**Amendment to the Drawings**

### **REMARKS/ARGUMENTS**

#### **Drawings**

Fig 4

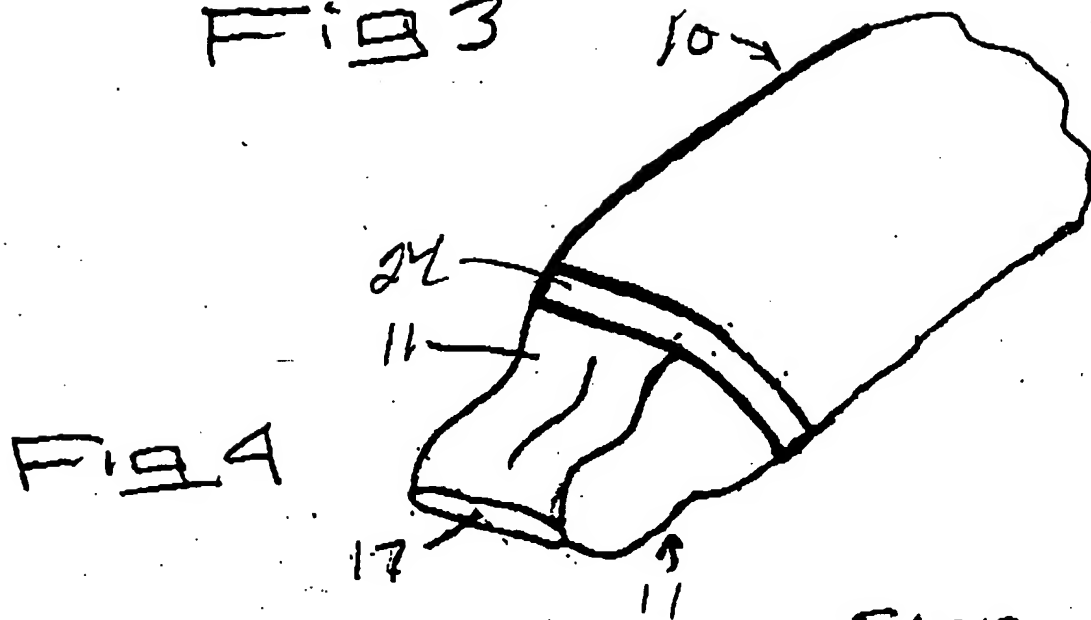
Applicant traverses the objections that: 1) the angle of the device in Figure 4 makes it difficult to determine the disposition of spreader 17 with respect to the nozzle 11; 2) and, Figure 29 should be broken into two individual drawing portions. Figure 4 is an embodiment in accordance with the inventor’s invention. Applicant submits that any requirement for the inventor to change this drawing would be unacceptable. Moreover, Figure 29 depicts a spreader with a cap, attached to a container. Applicant respectfully asserts that there is no need to separate the attached items in Figure 29 and include them in separate figures.

Fig 5

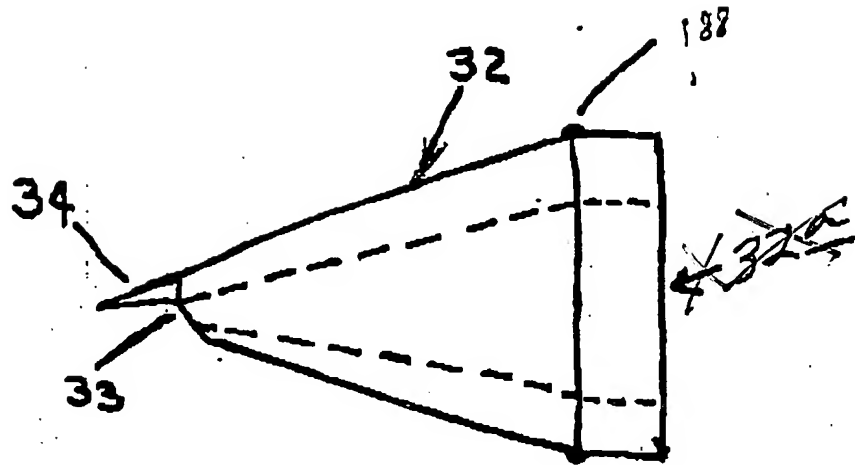
The attached replacement sheet of drawings includes changes to FIGS. 1, 2, 5, 6, 8, 15, 18, 19, 19a, 20, 22A, 22B, 23, 24, 25, 26, 28a, 28b, 30 and 31, as indicated in the replacement sheet of drawings attached hereto.

In response to the objections to the drawings, Applicant has amended the specification and submits herewith proposed replacements sheets wherein Figures 1, 2, 5, 6, 8, 15, 18, 19, 19a, 20, 24, 25, 30 and 31 wherein proposed corrections have been made. In particular: Figures 1 and 2 have been modified to include reference number 21; Figure 5 has been modified to remove reference number 32a; Figure 6 has been modified to correct the position of the lead line for reference number 189, remove an unnecessary line, and to depict threading; Figure 8 has been modified to replace reference number "34" with "87"; Figure 15 has been modified to make reference number "61a" clear; Figure 18 has been modified to show how the views in the figure interrelate; Figures 19 and 19a have been modified to replace reference number 110a' with 110b;

FIG 20

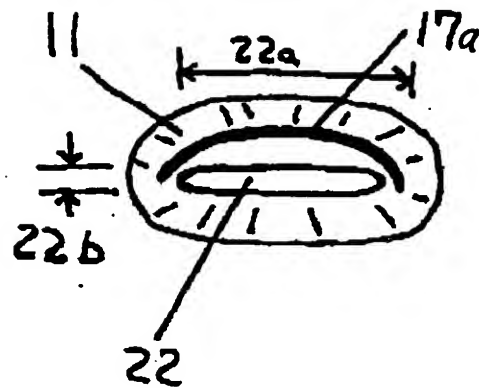
Figure 19 has been modified to replace the incorrect use of reference number “112a” with “102”; Figure 20 has been modified to replace the incorrect use of reference number “17” with “17a”; Figure 22A has been modified to include reference number/letters “313” and “P”; Figure 22B has been modified to include reference “P”; Figure 23 has been modified to include reference number 415 and a bracket to show a single entity; Figure 24 has been modified to include reference “F”; Figure 25 has been modified to include a bracket to show a single entity; Figure 26 has been modified to include reference number 601 and a bracket to show a single entity; Figure 28a has been amended to include reference number 807; Figure 28b has been amended to include a bracket to show a single entity; Figure 30 has been amended to include reference number “1004” and to show how the views in the figure interrelate; and, Figure 31 has been amended to move the location of “FIG 31”. The corrections do not add any new matter and approval of the proposed changes is respectfully requested.

FIGURE 23

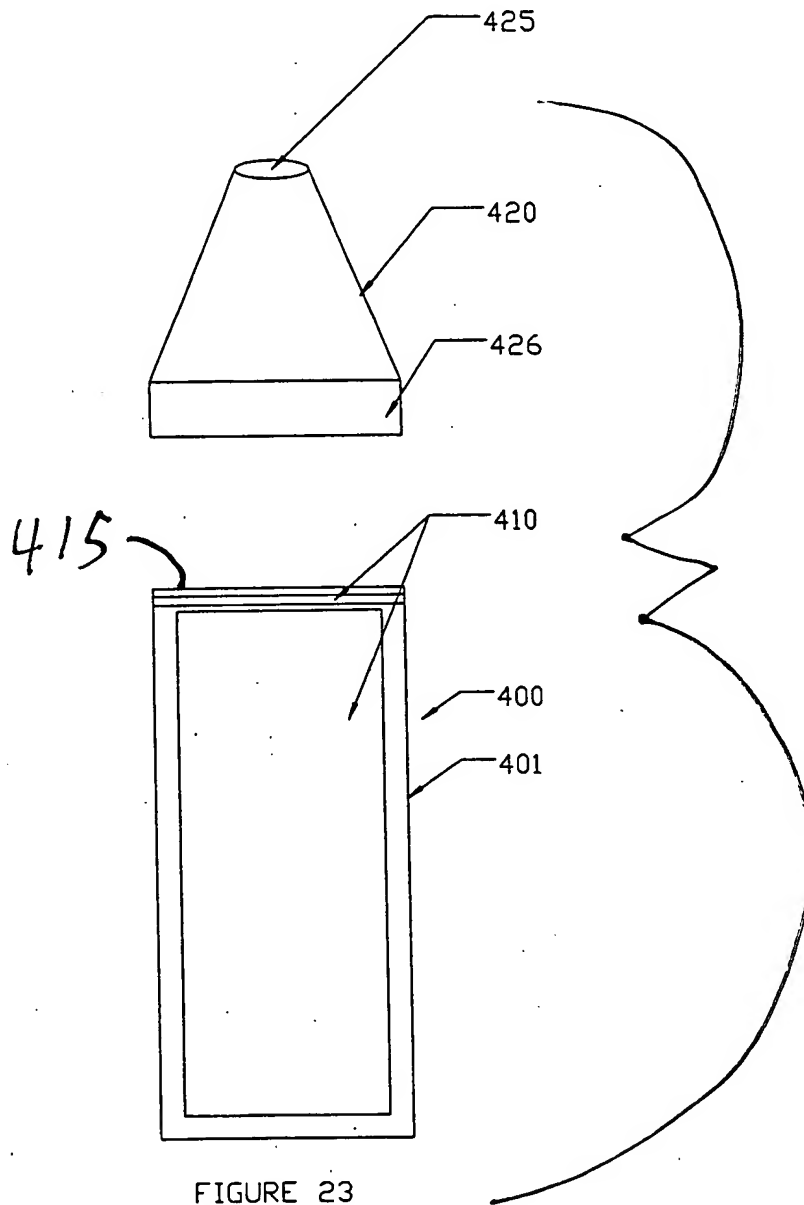
With regard to the newly added reference numbers, reference number 415 within Figure 23 is included in the specification by replacing reference number 426 on page 16, line 22, of the originally filed specification. Reference number 601 is include in the specification by added the statement that the spreader “is attachable to container 601.”
